STAFF REPORT  
(ONE-STEP FINAL PLAT)

**CASE NUMBER:** SUB 2002-21 -- CENTRAL AND ROCK ADDITION

**STAFF REPORT**  
(ONE-STEP FINAL PLAT, DEFERRED 3/14/02)

**CASE NUMBER:** SUB 2002-21 -- CENTRAL AND ROCK ADDITION

**VICINITY MAP**

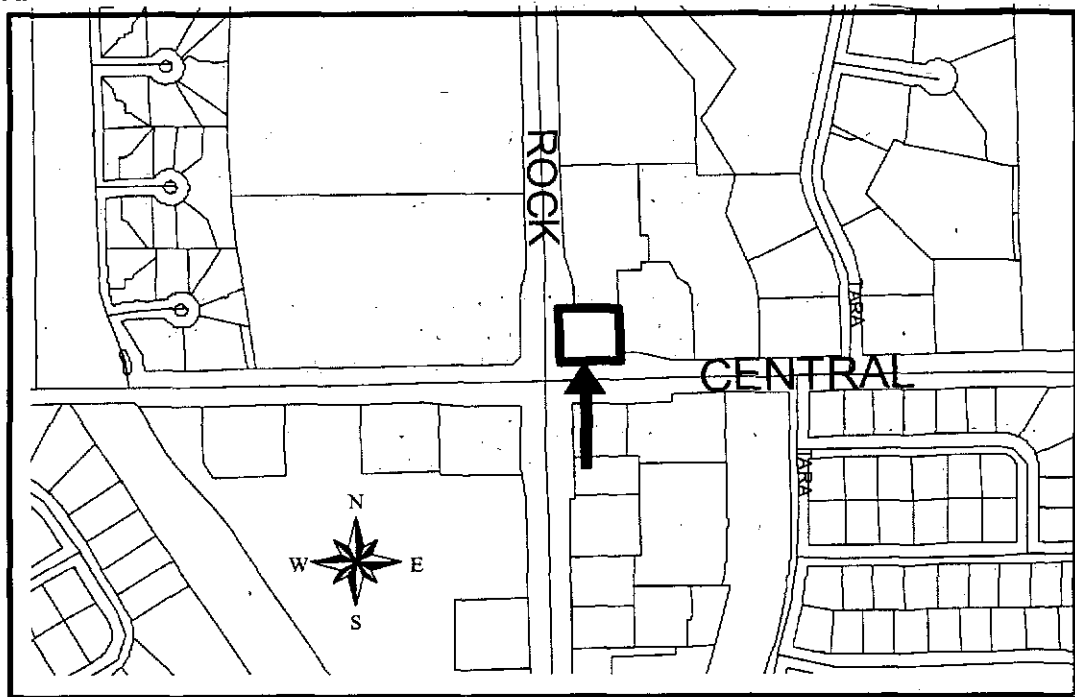
- A. Municipal services appear to be available to serve the site. **City Engineering** needs to comment on the need for guarantees or easements.
- B. If improvements are guaranteed by petition, a notarized certificate listing the petitions shall be submitted to the Planning Department for recording.

- C. **City Engineering** needs to comment on the status of the applicant's drainage plan.
- D. The plat proposes one access opening along both Central and Rock Road. Distances should be shown for all segments of access control. **Traffic Engineering has required complete access control along Central. One opening along Rock Road is permitted.**

- E. The applicant shall guarantee the closure of any driveway openings located in areas of complete access control or that exceed the number of allowed openings.

- F. **Traffic Engineering** needs to comment on the need for additional right-of-way, whether an outright dedication or contingent dedication. The Subdivision Regulations require a 75-ft half street right-of-way at the intersection of arterials. The applicant has platted a triangular corner clip with a 50-ft right-of-way along Central and a 60-ft right-of-way along Rock Road.

- G. The applicant shall submit an avigational easement covering all of the subject plat and a restrictive covenant assuring that adequate construction methods will be used to minimize the effects of noise pollution in the habitable structures constructed on subject property.

- H. The owners noted in the platting binder need to be signatories to the plat.
- I. The platator's text shall include language that a drainage plan has been developed for the plat and that all drainage easements, rights-of-way, or reserves shall remain at established grades or as modified with the approval of the applicable City or County Engineer, and unobstructed to allow for the conveyance of stormwater.

**VICINITY MAP**

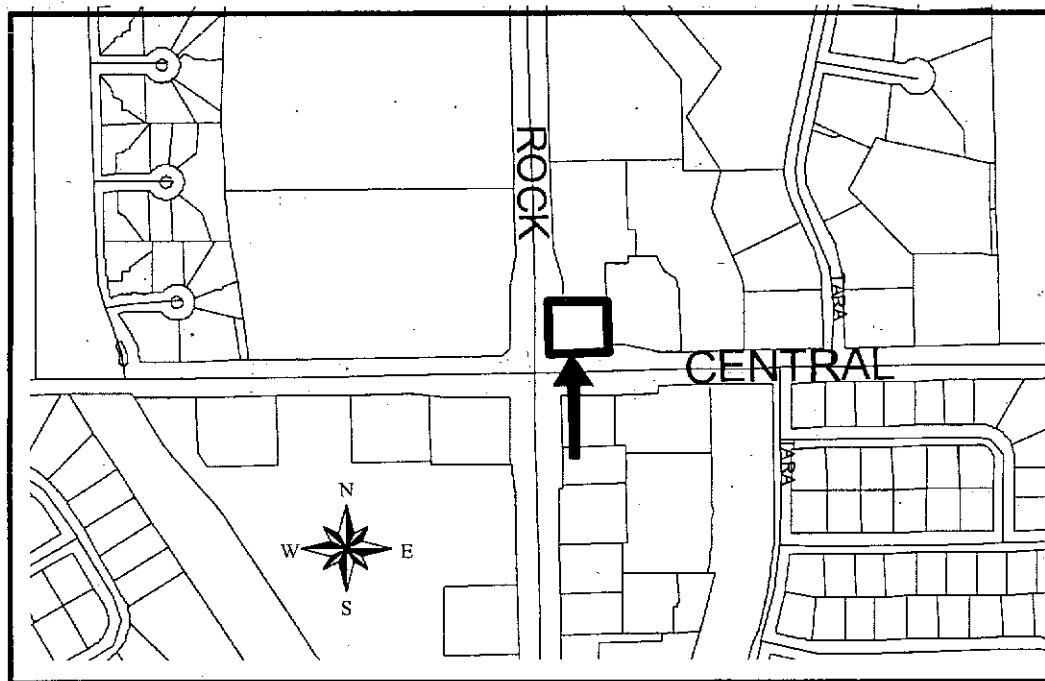
- A. Municipal services are available to serve the site. **City Engineering** needs to comment on the need for guarantees or easements. **No guarantees or easements are required.**

- C. **City Engineering** needs to comment on the status of the applicant's drainage plan.
- D. The plat proposes one access opening along both Central and Rock Road. Distances should be shown for all segments of access control. **The proposed access openings have been approved. If a cross-lot access agreement can be obtained with the abutting properties to the east and north, then both driveways shall be closed.**

- F. **Traffic Engineering** needs to comment on the need for additional right-of-way, whether an outright dedication or contingent dedication. The Subdivision Regulations require a 75-foot half street right-of-way at the intersection of arterials. The applicant has platted a triangular corner clip with a 50-foot right-of-way along Central and a 60-foot right-of-way along Rock Road. **Traffic Engineering has requested a 10-foot contingent street-dedication.** 10' UE
